Subject: **Addendum to Geotechnical Report/Critical Area Study –
Critical Area Mitigation Sequencing**
Proposed Landscape Improvements
8636 North Mercer Way
Mercer Island, Washington

Reference: *Geotechnical Engineering Study and Critical Area Study*, same site and project;
Geotech Consultants, Inc.; November 20, 2024.

**SUBJECT: SUPPLEMENTAL RECOMMENDATIONS AND
GEOTECHNICAL REVIEW**

Proposed Residence Replacement
8636 North Mercer Way
Mercer Island, Washington
Project No. 10-117-01

Figure 6

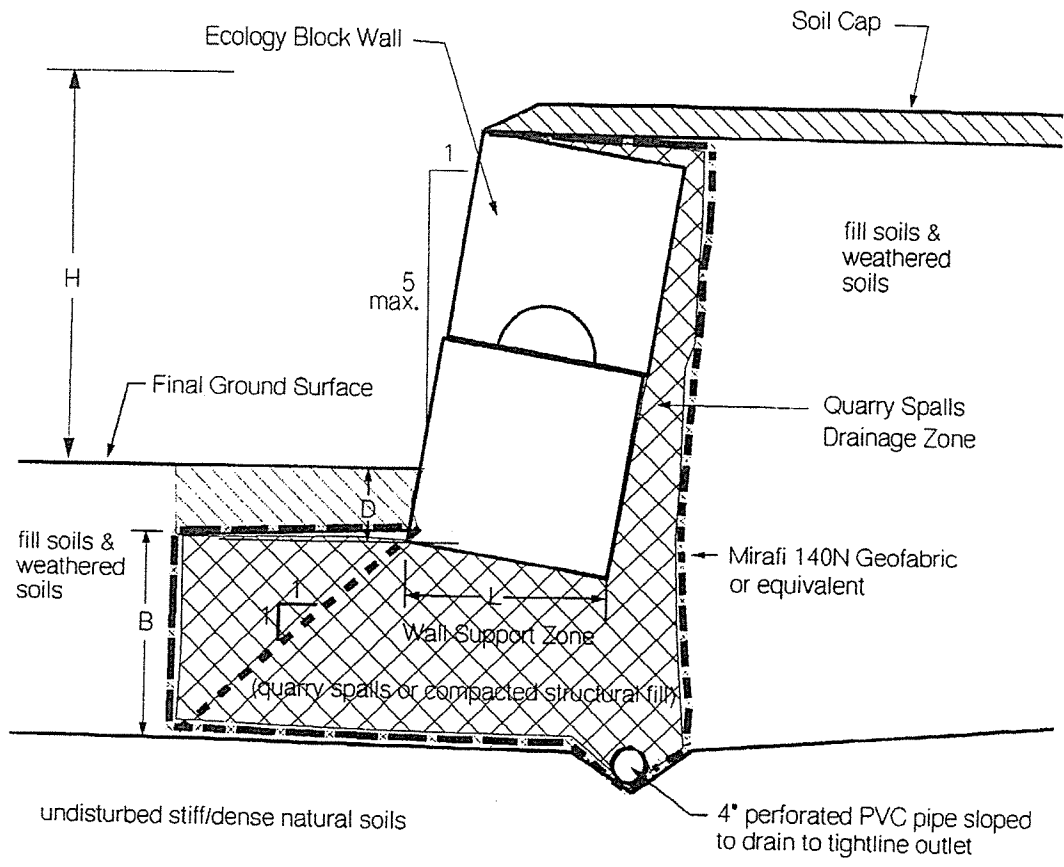
Rockery Detail: We understand that rockeries are proposed to support grade changes up to 4 feet in height in landscape areas along the lower side of the residence and on the upper side of the proposed detached garage. Based on our previous site explorations we expect the areas where rockeries are proposed may have fill and/or weathered soils exposed at the ground surface. We recommend that where fill and/or weathered soils are exposed at the proposed rockery location, the existing soils should be excavated and replaced with a zone of structural fill or quarry spalls for support of the rockery. The detail of Figure 6 attached, presents our recommendations for support and construction of the proposed rockeries.

Based on our review we find the rockery and ecology block wall facing details on the referenced C3.1 sheet to be in conformance with our supplemental recommendations for rockeries and ecology block walls as presented in this letter and the attached Figures 6 and 7.
